**NEBRASKA ARMY NATIONAL GUARD
SEWARD MUSEUM REMODEL – PHASE 2**

PROJECT NO. 31030123

A D D E N D U M N O . 1

K4R/A1.2 SECTION DETAIL - ROOF HATCH

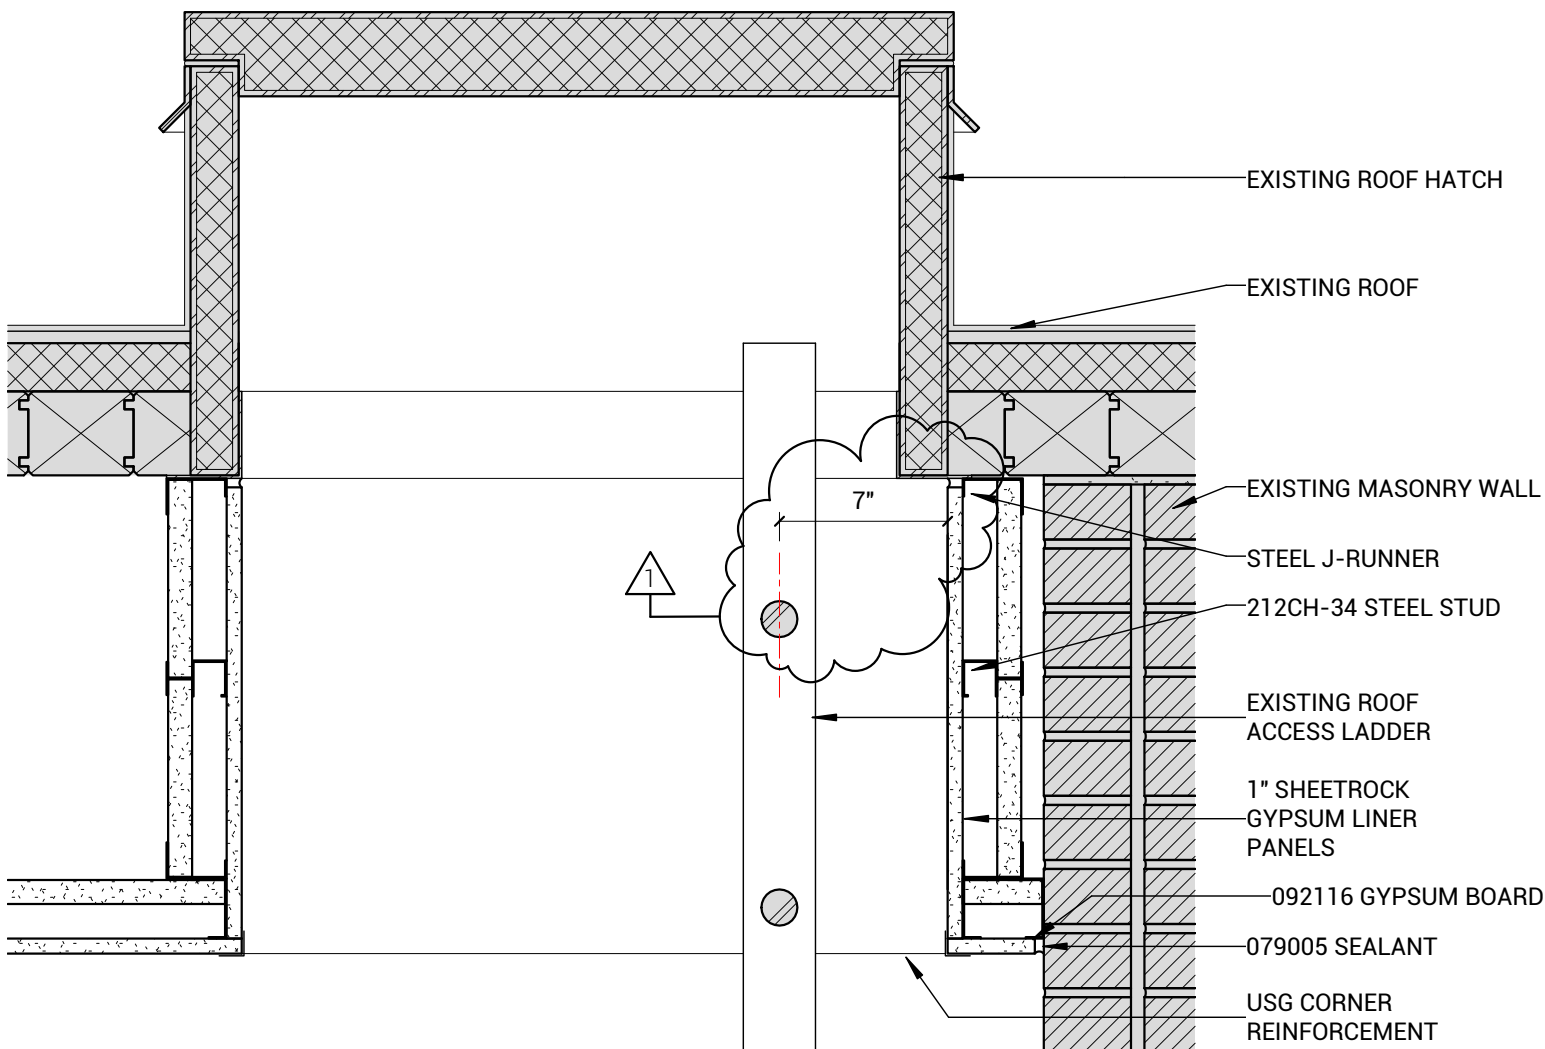
1. Reference detail K4.
 - a. See drawing 11 for changes to shaftwall ceiling.
 - b. See drawing See drawing 15-detail A12R/A1.2 for revisions to Clerestory/Soffit Plan ABI window type clarification.
 - c. Reference detail A12. Delete box note at lower right corner that reads: "Note: Paint All Ductwork EP-1".

L19R/A1.3 SECTION DETAIL - FRESH AIR HOOD

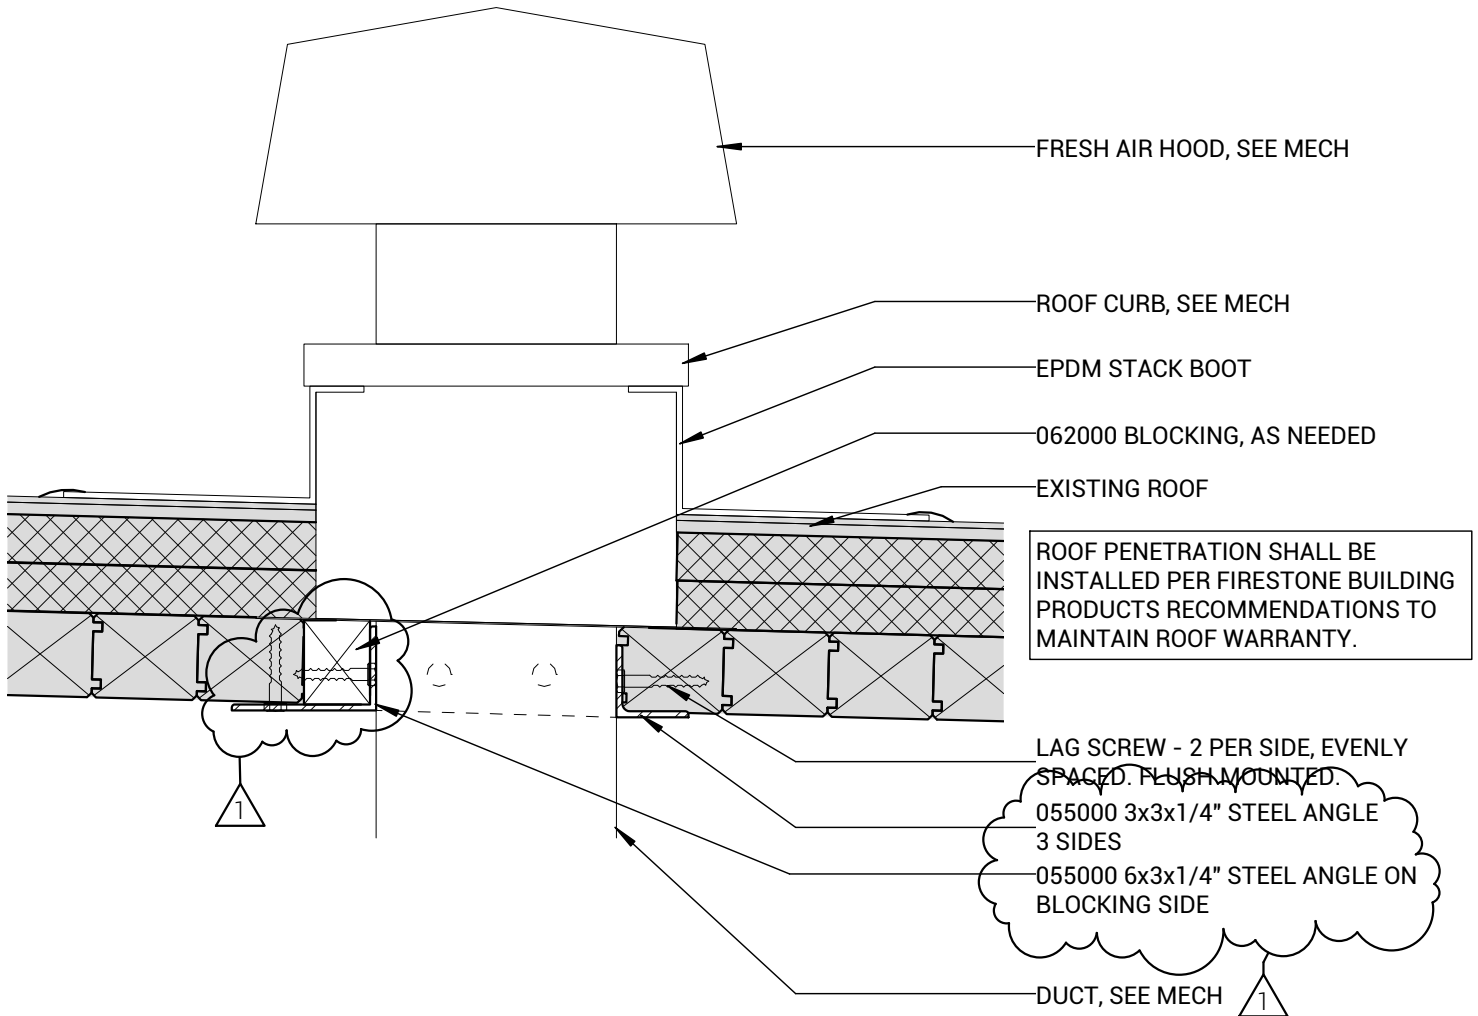
1. Reference details L19 and S19.
 - a. See drawings 12 and 13 respectively for revisions to angle supports for new roof openings.
2. Reference detail A13.
 - a. Remove detail box A10/A5.3 from lower left corner of Roof Plan.
 - b. Change note in Box just below new rooftop unit on west side to read:
 - i. SEE DETAIL P2/A5.1 FOR PENETRATION DETAILS.

F1R/A5.2 GUARDRAIL SECTION - TYP

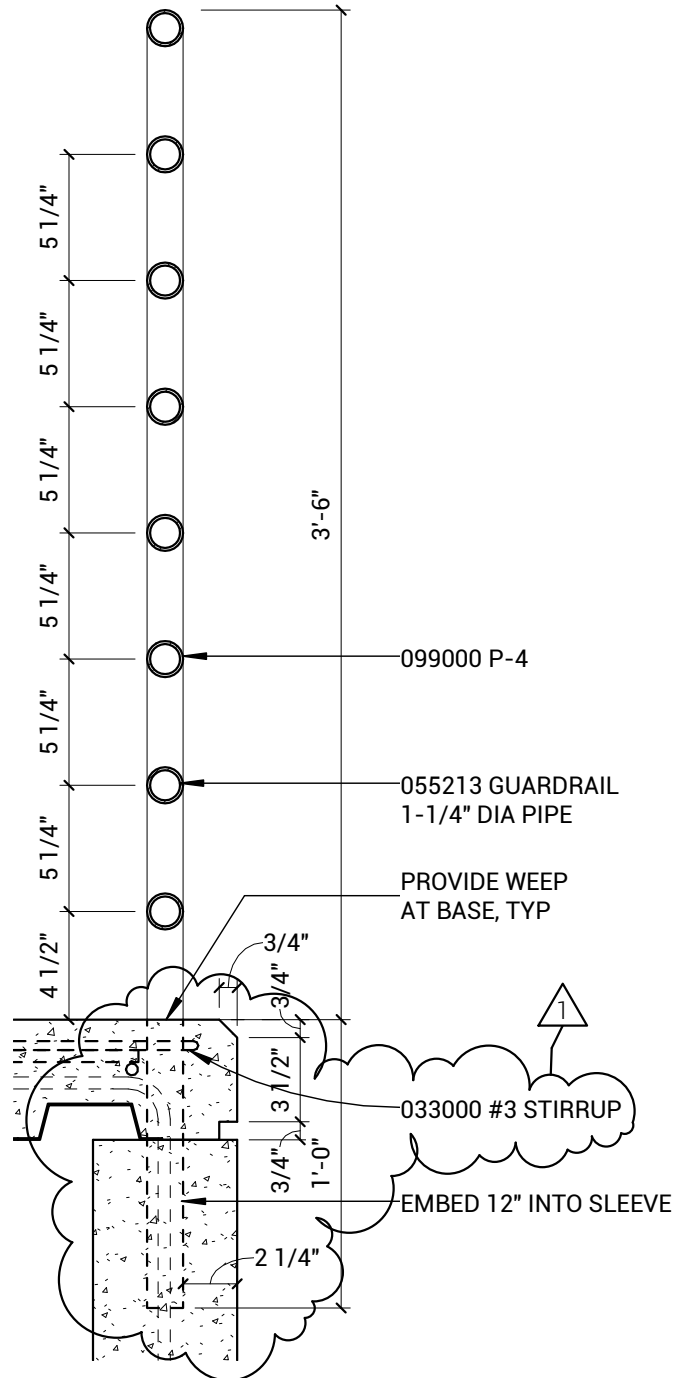
- ADD 2-13 Sheet A5.2.
1. Reference detail A1.
 - a. See drawing 8-detail A1R for wall rail elevation.
 2. Reference detail F1.
 - a. See drawing 14 for changes to guardrail detail.

G12R/A3.1 NORTH ELEV
1/8" = 1'-0"

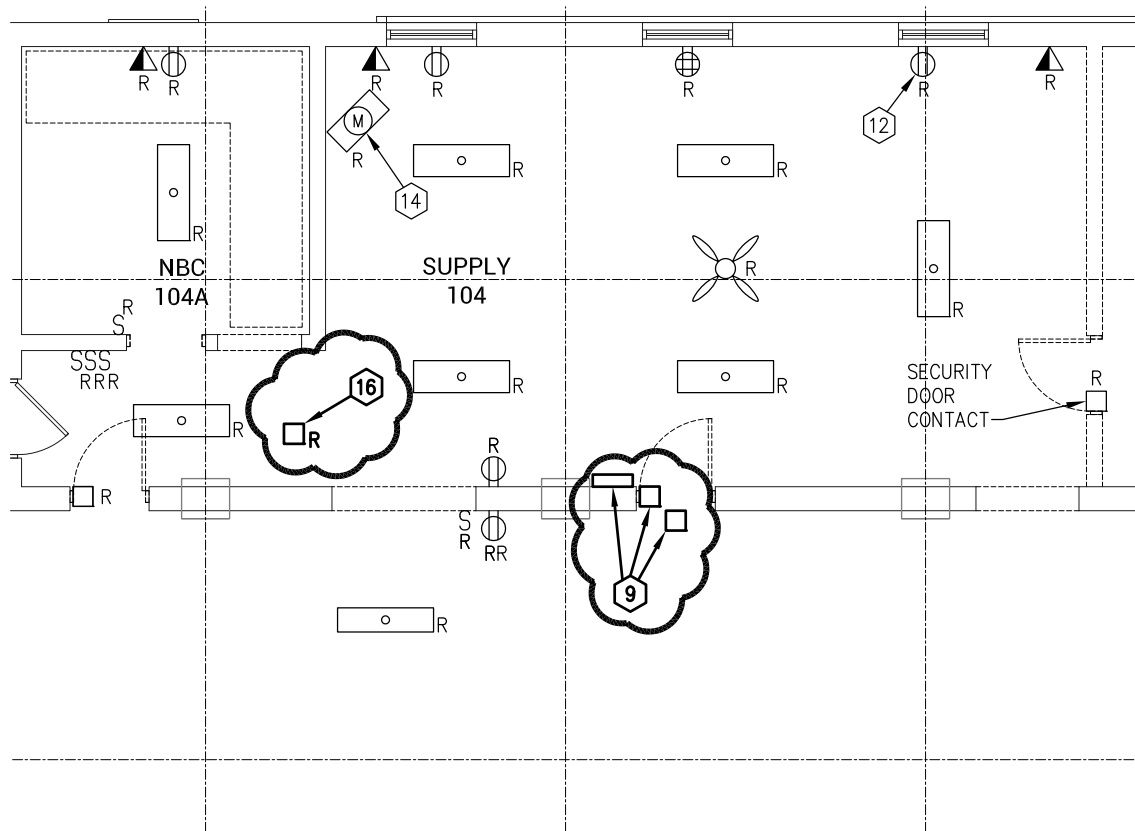
- ADD 2-12 Sheet A3.1.
1. Reference detail G12.
 - a. Section cut obscured by Gridline B shall read P1/A6.1.
 - b. See drawing 16-detail G12R. Window located on First Floor between Gridlines A and B shall be replace with Type 2 glass.

SHEET
E1.0

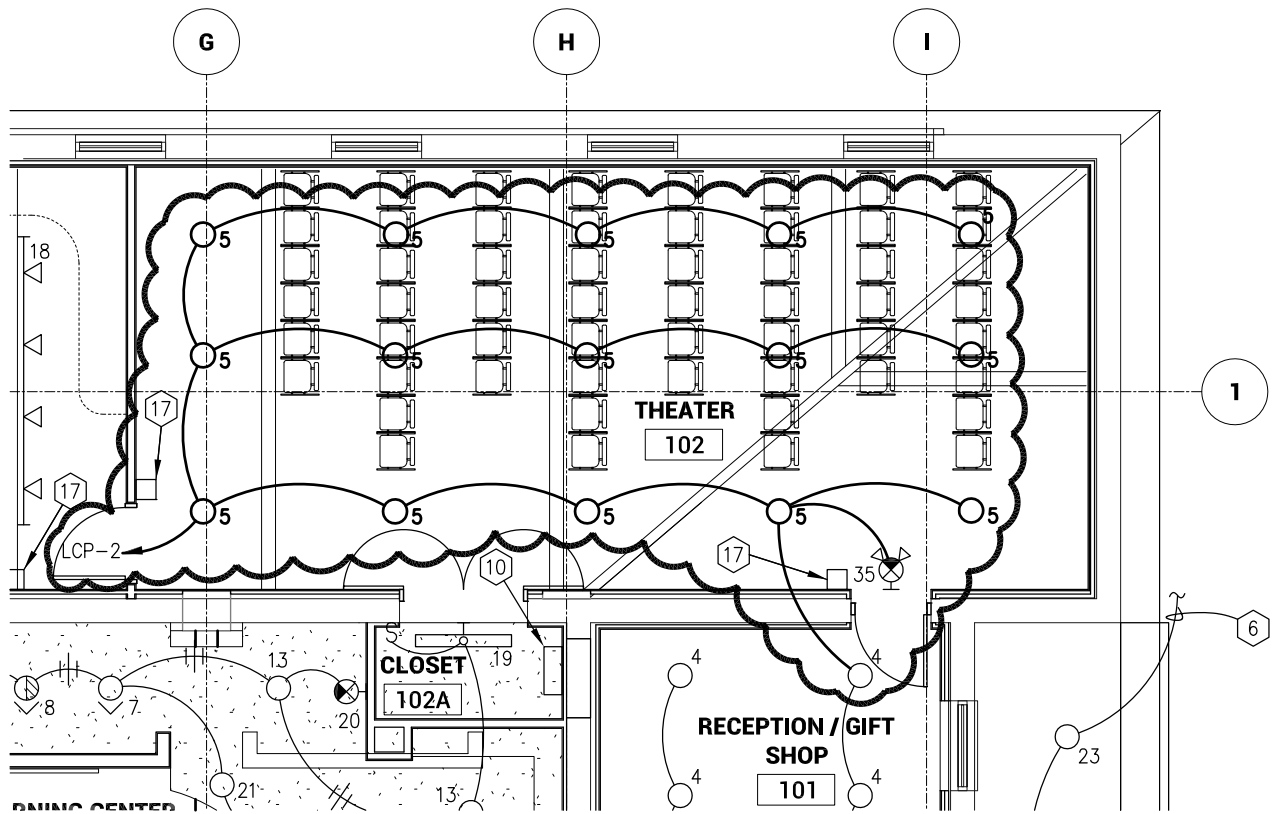
- f. Change grid line E to grid line G.
 - g. Change grid line F to grid line H.
 - h. Change grid line G to grid line I.
2. Remove and relocate existing security equipment on southeast door of Supply 104.
 3. Sheet Notes:
 - a. Revise Note 9 to read: Remove and relocate existing security contacts and equipment for IDS System. Relocate to new door south of Corridor 105. See Sheet E3.0 for new location.
 4. Remove existing light switch for exterior lights in Stair 003, Storage/Work 007, and Kitchen 108.
 5. Remove existing motion detector in Supply 104 and return to Owner. See attached drawing Sheet E1.0 Attachment No. 1.

- REMOVE AND RELOCATE EXISTING SECURITY CONTACTS AND EQUIPMENT FOR IDS SYSTEM AND RELOCATE TO NEW DOOR AND SOUTH OF CORRIDOR 105. SEE SHEET E3.0 FOR NEW LOCATION.

E2.0

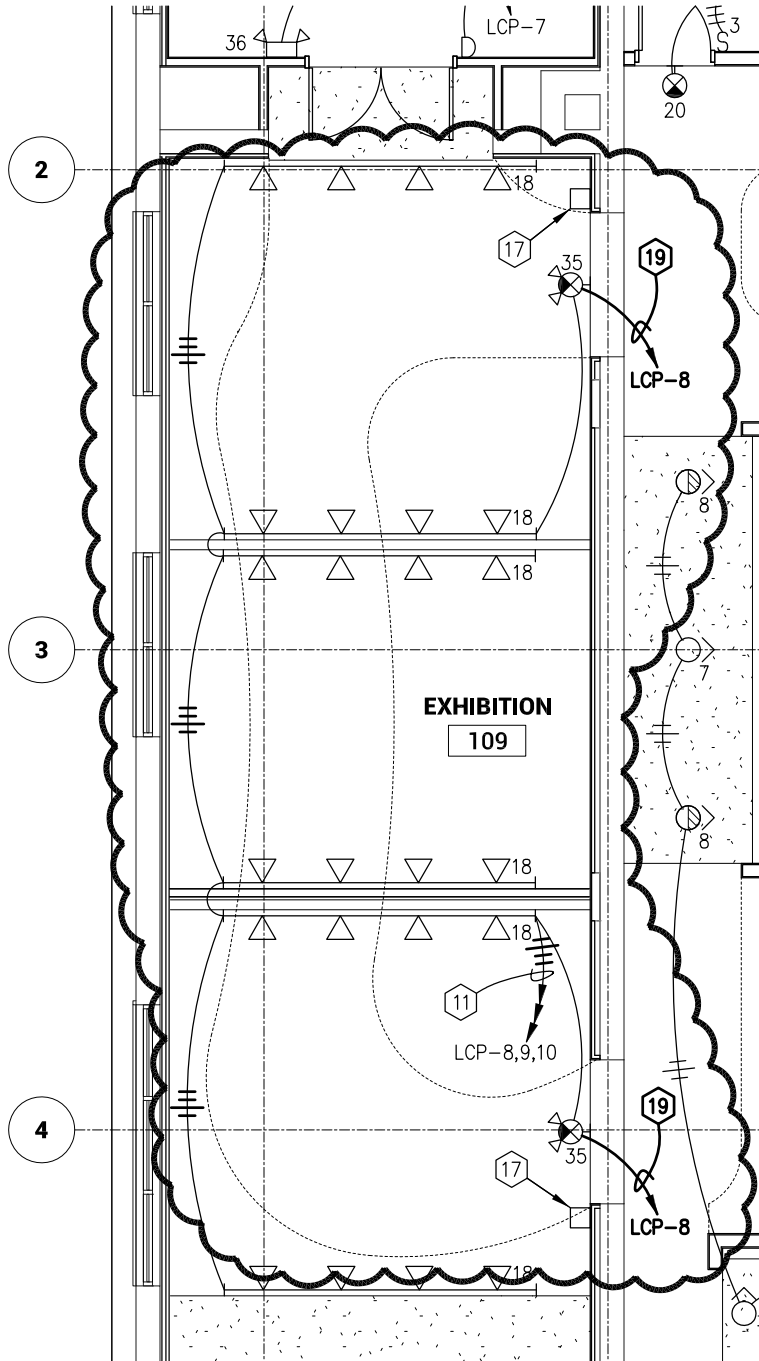
- f. Change grid line E to grid line G
 - g. Change grid line F to grid line H
 - h. Change grid line G to grid line I
4. Revise lighting layout in Theater 102. See attached drawing Sheet E2.0 attachment No. 1.

SHEET
E2.0

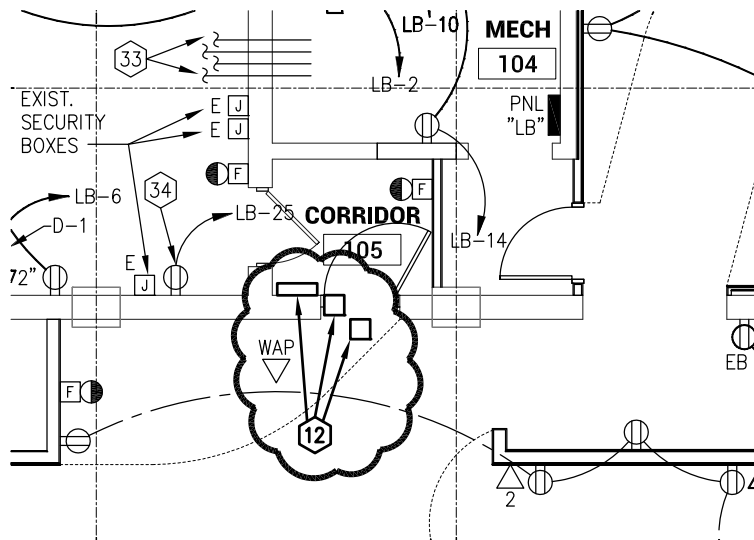
5. Move light switch to south side of door in Men's RR 118.
6. Modify circuiting in Exhibition 109 to accommodate combination exit sign and emergency lighting. See attached drawing Sheet E2.0 attachment No. 2.

E3.0

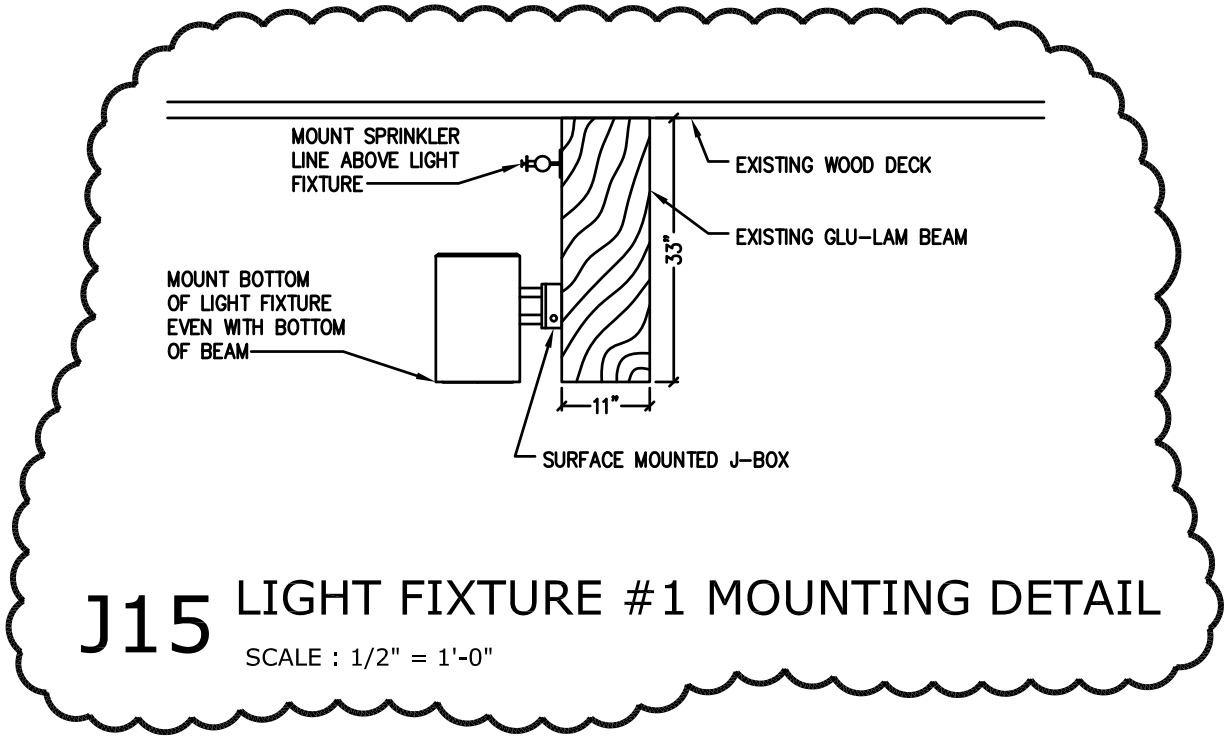
3. Existing boxes for receptacles near sinks in Women's RR 114 and Men's RR 118 are mounted above sink height.
4. Relocated existing security contacts and security equipment for IDS system to door south of Corridor 101. See attached drawing Sheet E3.0 attachment No. 1.

9. Remove security door contact and motion detector on Mech 104 door. See attached drawing Sheet E3.0 Attachment No. 1.

- RELOCATED CONTACTS AND SECURITY EQUIPMENT FOR IDS SYSTEM. SEE SHEET E1.0 FOR PREVIOUS LOCATION. COORDINATE INSTALLATION WITH OWNER.
